Project Change Request Form

Windmill Lane Southern Level Crossing change (Option L6 – L7)

Change Proposal: Level1 Change Ref No.36 / PCRf No._____

Document Reference Numbers: 146119-NWR-AA_000-ZZZ-CHG-MPM-000004

Figure 2: Option L6 key infrastructure features

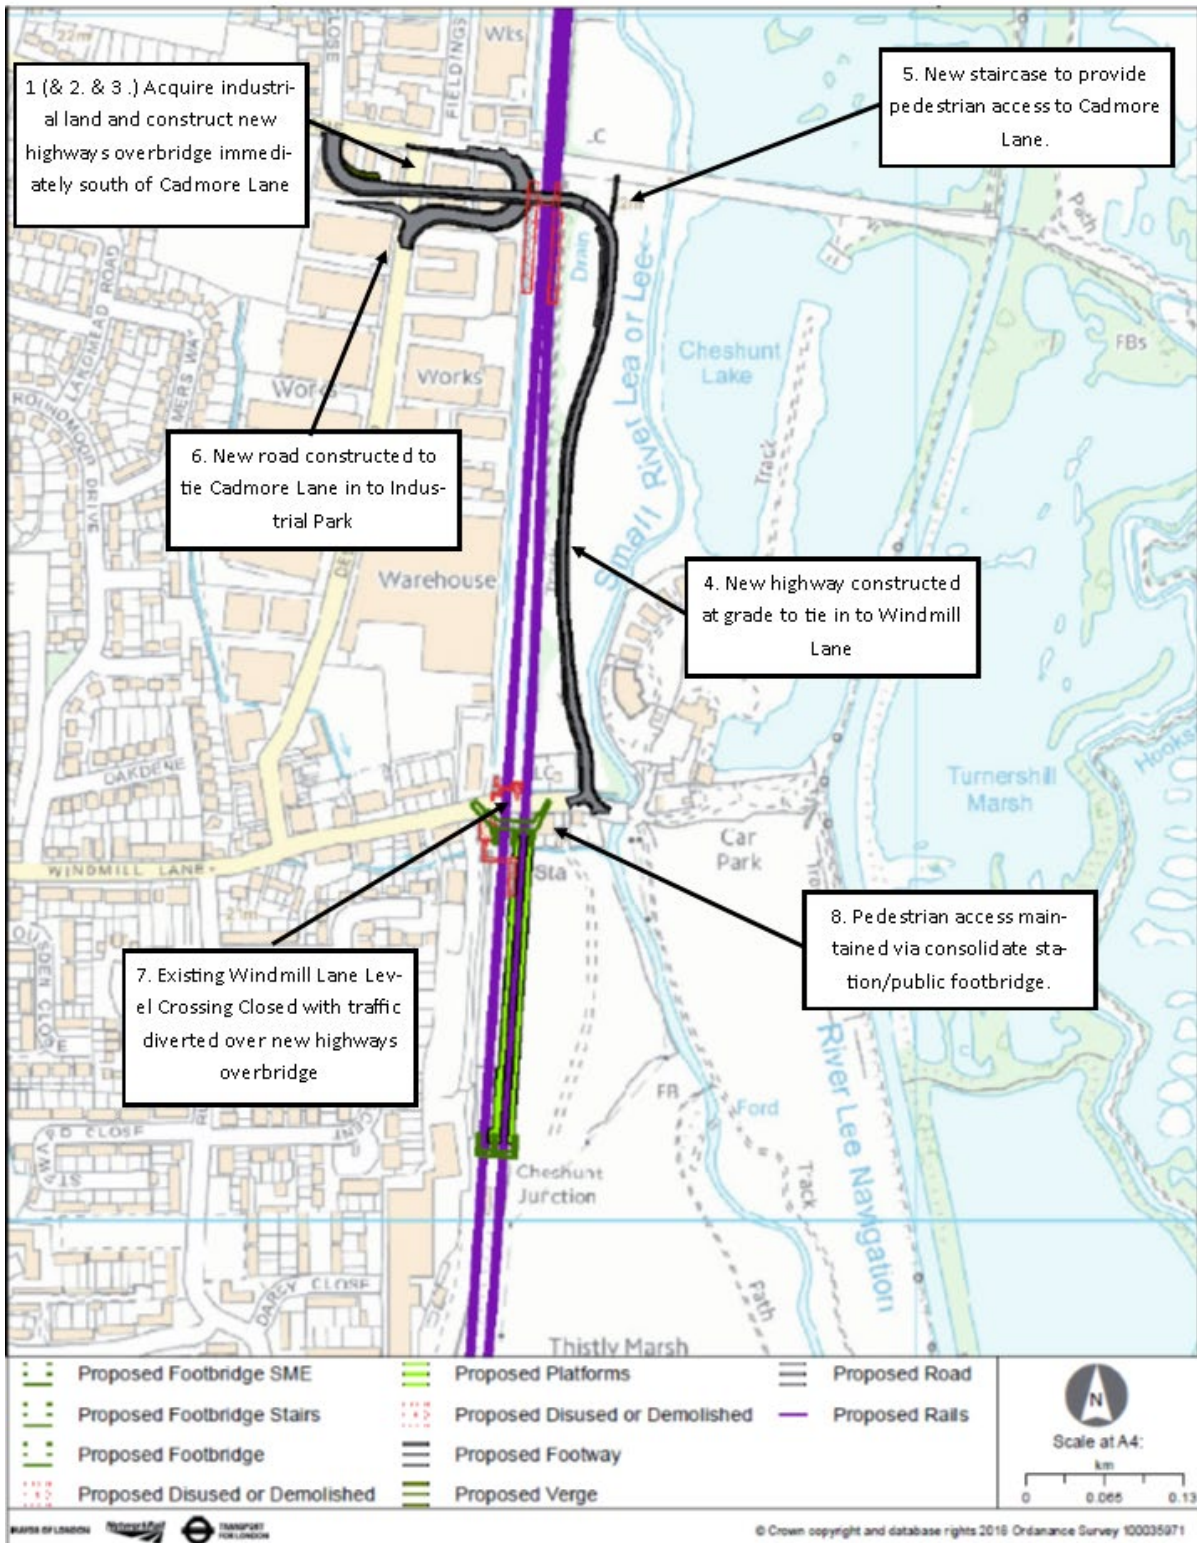
The previous option (L6) provides a rail overbridge North of the existing level crossing, with a Western tie-in to Cadmore Lane and Eastern tie-in to Windmill Lane. It also includes a link for pedestrians from the overbridge to Cadmore Lane (east). Option L6 requires significant land take on the Western side of the railway from an industrial zone that has been designated part of the Cheshunt Lakeside masterplan and pre-submission Local Plan.

The Northern Option (Option L6) design proposal can be summarised as follows:

1. Acquire industrial land to the West of the rail corridor and demolish existing buildings.

2. Construction of new highways overbridge immediately South of Cadmore Lane spanning the rail corridor.
3. Highways bridge tied into Cadmore Lane on the Western side of the railway.
4. New highway constructed at grade to tie highways over bridge into Windmill Lane of the Eastern side of the railway.
5. Staircase constructed to tie new highways overbridge into Cadmore Lane on the West of the highway to provide pedestrian access.
6. New road constructed underneath new highways over bridge on the Western side of the rail corridor to tie Cadmore Lane into the industrial park to the north of Cheshunt Station.
7. Existing Windmill Lane level crossing closed with vehicular traffic diverted over the new highways over bridge.
8. Pedestrian access across the railway at Windmill Lane level crossing maintained through new stairs / lifts provided as part of Cheshunt Station works.

Figure 4: Option L7 infrastructure key features

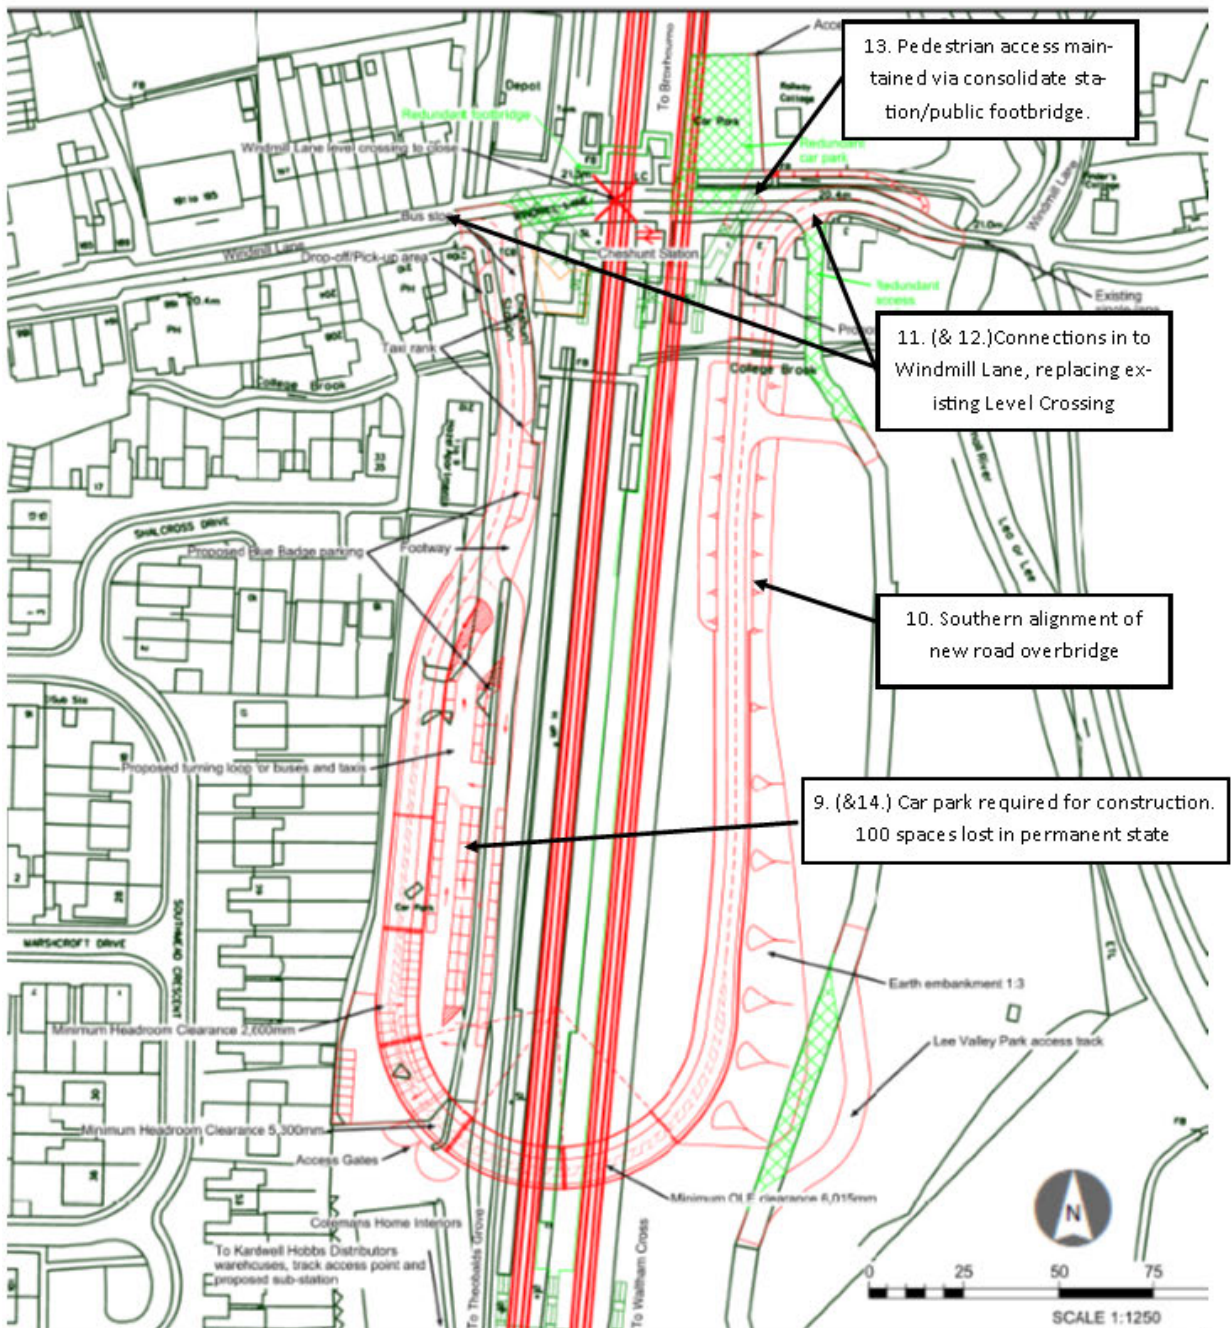
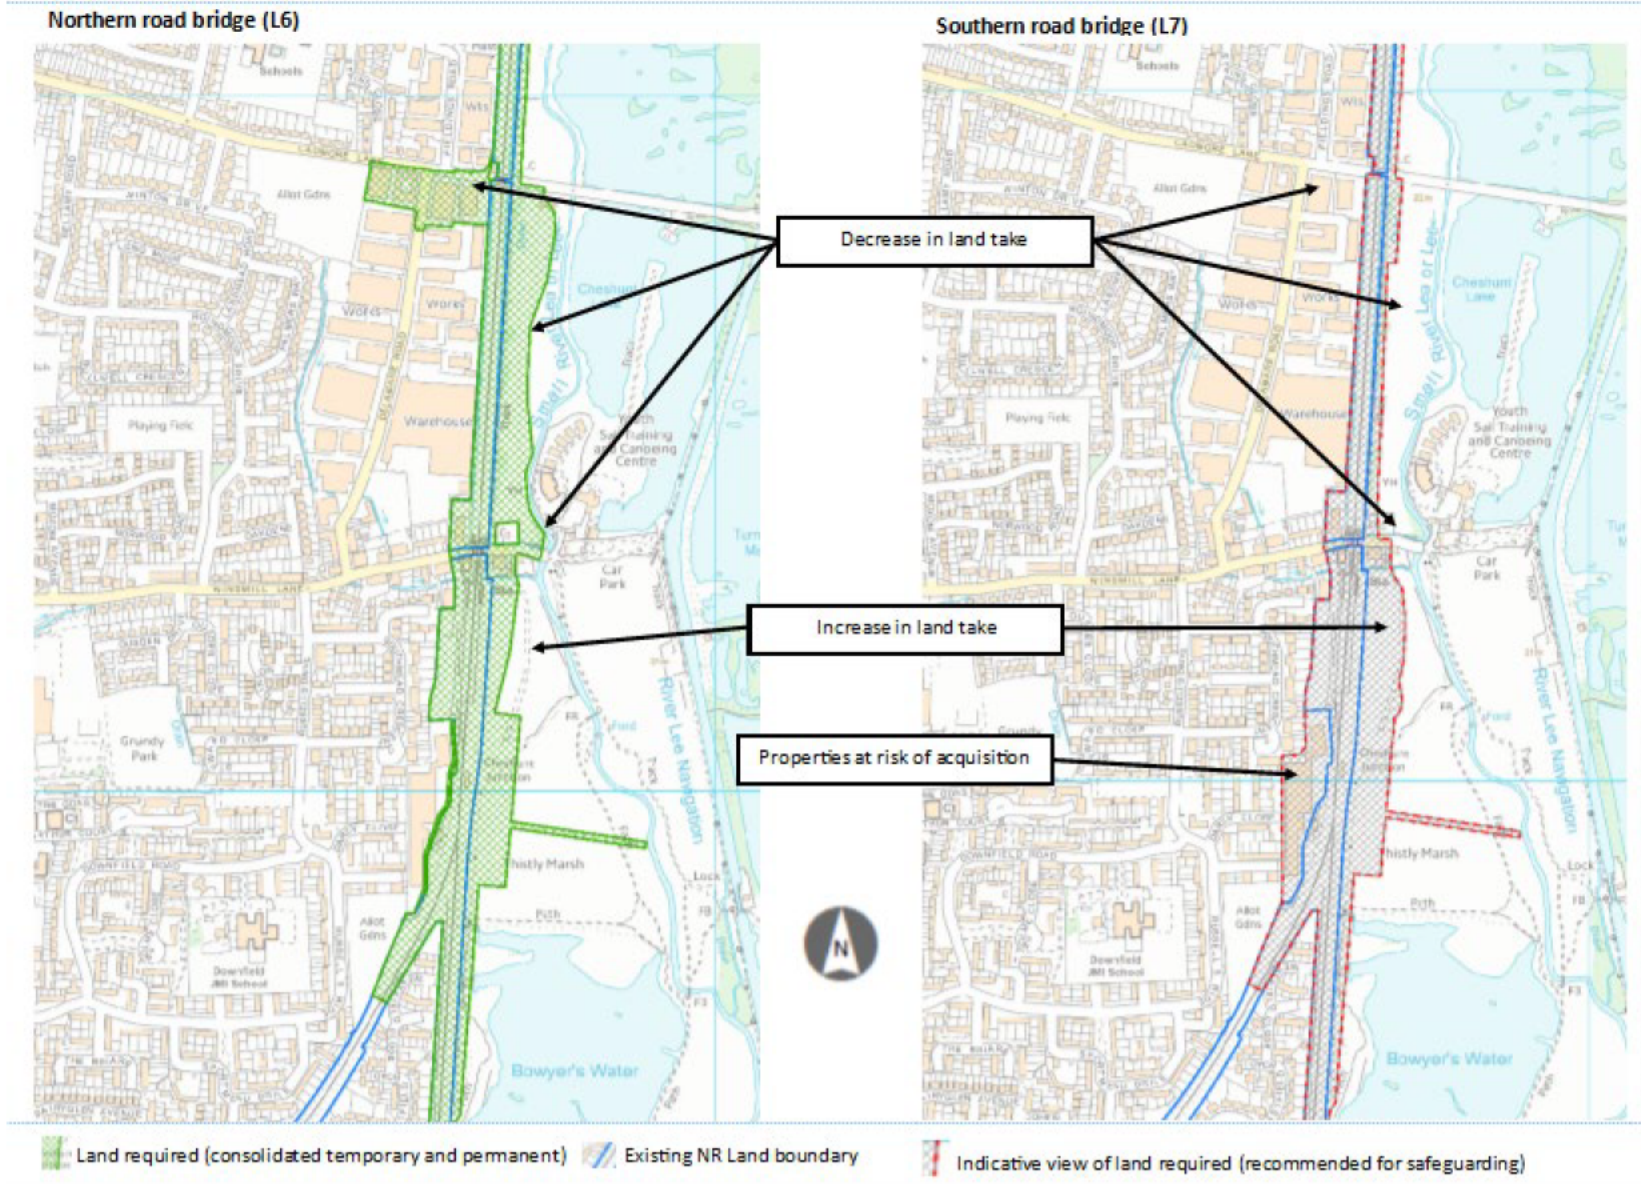
The new option (L7) provides a rail overbridge South of the existing level crossing spanning over the southern end of Cheshunt station tying into Windmill Lane on both the eastern and Western sides of the Railway. To facilitate construction of L7 the station car park will need to be used as a worksite. In the final state it will be reinstated with the loss of C.100 parking spaces. Option L7 eliminates the impact on the Cheshunt Lakeside development and pre-submission Local Plan.

The Southern Option (Option L7) design proposal can be summarised as follows:

9. Cheshunt Station car park temporarily acquired as a construction worksite.
10. Construction of new highways over bridge immediately South of Cheshunt Station spanning the rail corridor and avoiding conflict with Cheshunt Lakeside development site.
11. Highways bridge tied into Windmill Lane on both the Eastern and Western side of the railway.
12. Existing Windmill Lane level crossing closed with vehicular traffic diverted over the new highways over bridge.
13. Pedestrian access across the railway at Windmill Lane level crossing maintained through new stairs / lifts provided as part of Cheshunt Station works.
14. Cheshunt Station car park reinstated with loss of C. 100 spaces.
